E6198A-04A

S E R V I C E N O T E

E6198A Switch Load Unit (SLU)
- used in E8780A/B/BZ, E8781A, E8786A/B/BZ,
E2240A/AZ, N9380A, and Z2410A

Enhancement solution is available to SLU backplane discoloration issue by removing the preload resistors from backplane.

Figure 1. Discoloration mark on the SLU backplane near the area of preload resistors.

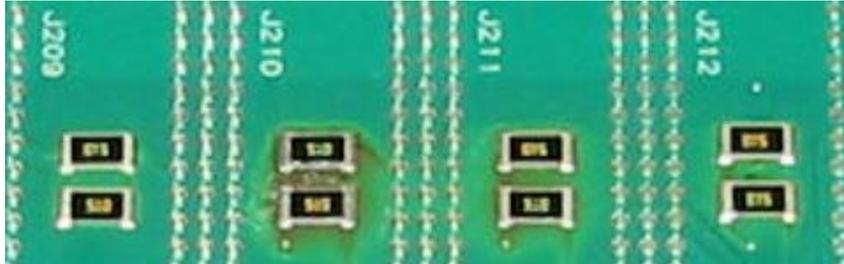
Agilent has recently received some feedbacks regarding the discoloration marks seen on the SLU backplane (E6170-66502) near the area of preload resistors (see Figure 1). As proactive response to the feedbacks, we have done the root cause analysis and safety evaluation on the backplane. The result shows that this discoloration mark was due to heating from the resistors and it will NOT cause any safety concerns.

Despite the SLU backplane is still safe to be used, Agilent would like to offer an enhancement solution to the matter by removing the preload resistors from the backplane. The removal will bring the following benefits to the users (1) prevent the discoloration from further deteriorating, (2) extend the life span of the backplane, and (3) increase the current consumption bandwidth of internal power supply.

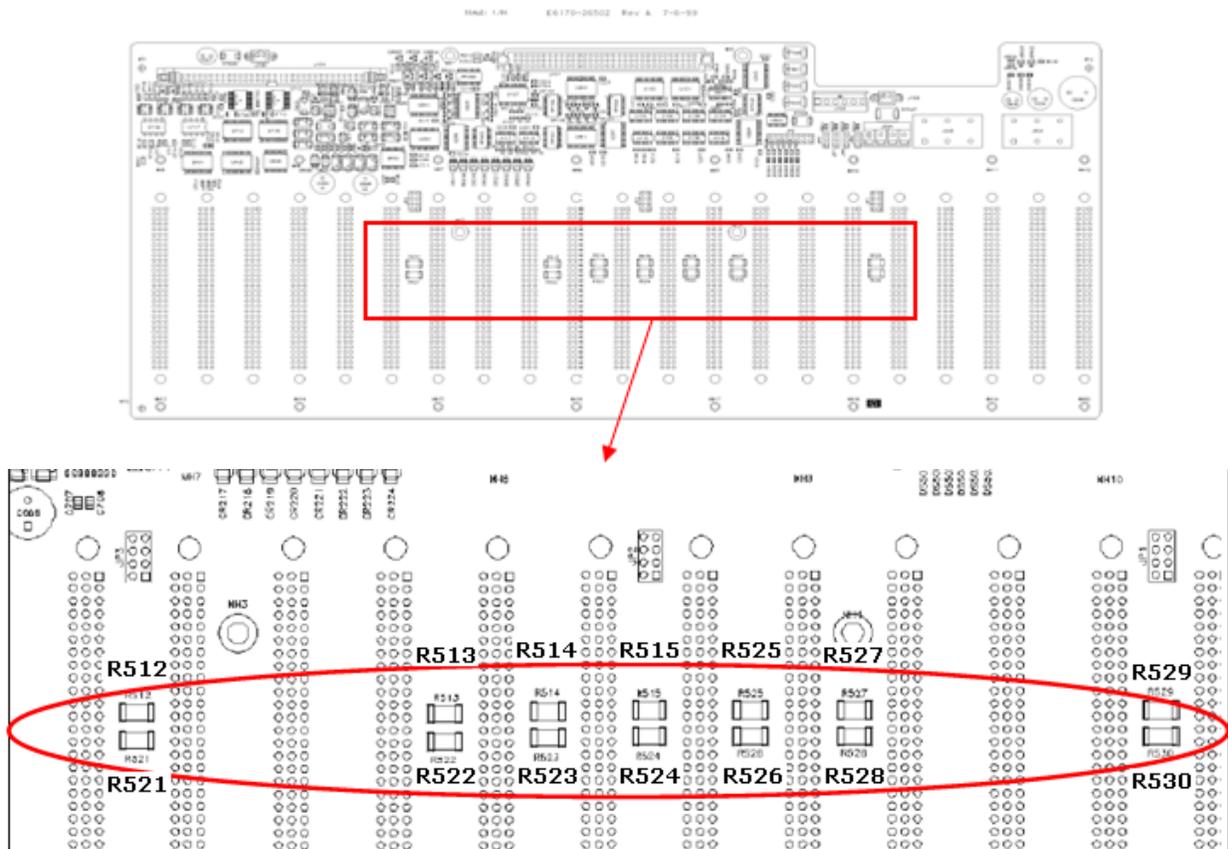
- Remove the 14 preload resistors (circled in red) from the backplane using Agilent recommended Chip Component Removal method stated in the IPC-7711A/7721A (or equivalent). Make sure the de-soldering work is clean to avoid short circuits.
